SUBJECT: OCONEE NUCLEAR STATION, UNITS 1, 2, AND 3 (ONS) - REQUEST FOR ADDITIONAL INFORMATION (RAI) REGARDING THE LICENSE AMENDMENT REQUESTS (LARs) FOR UPGRADING THE LICENSING BASIS FOR HIGH ENERGY LINE BREAK MITIGATION (TAC NOS. ME5202, ME5203, ME5204, ME5205, ME5206, AND ME5207)

REQUEST FOR ADDITIONAL INFORMATION (RAI)
LICENSE AMENDMENT REQUESTS (LARs)
TO REVISE PORTIONS OF THE UPDATED FINAL SAFETY ANALYSIS REPORT (UFSAR)
RELATED TO THE
TORNADO AND HIGH ENERGY LINE BREAK (HELB) MITIGATION LICENSING BASIS
DUKE ENERGY CAROLINAS, LLC
OCONEE NUCLEAR STATION, UNITS 1, 2, AND 3 (ONS)
DOCKET NOS. 50-269, 50-270, AND 50-287

Sketch RAI-87

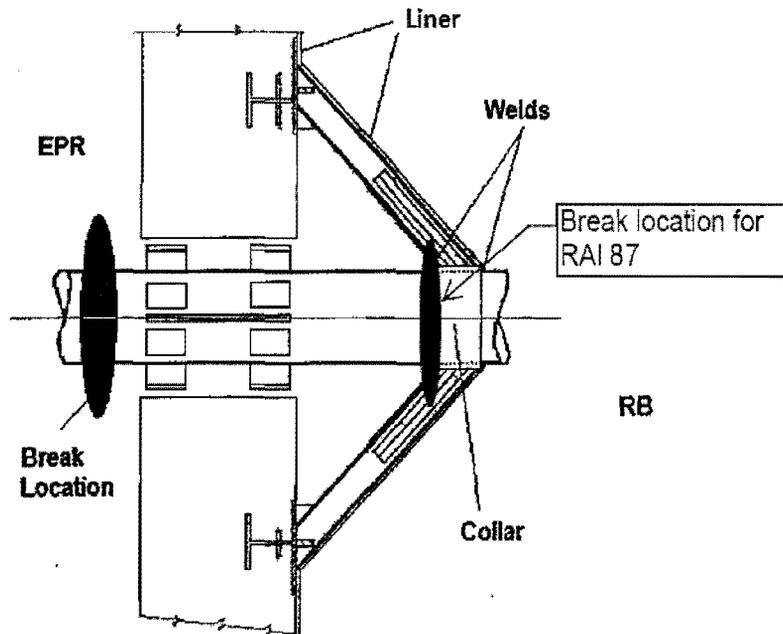
It is not clear in the licensee's October 23, 2009, response to RAI 10 how the containment liner was evaluated for jet impingement and pressurization loads resulting from the break depicted in the RAI response.

Please address whether the potential attenuation of loading, due to the presence of the reactor building wall between the break and the liner, was credited for in the evaluation.

Discuss a postulated terminal end break outside the containment boundary on the main steam anchor (see sketch below), and evaluate the effect that this break will have on the containment integrity or provide a technical justification why such a break is not required to be postulated.
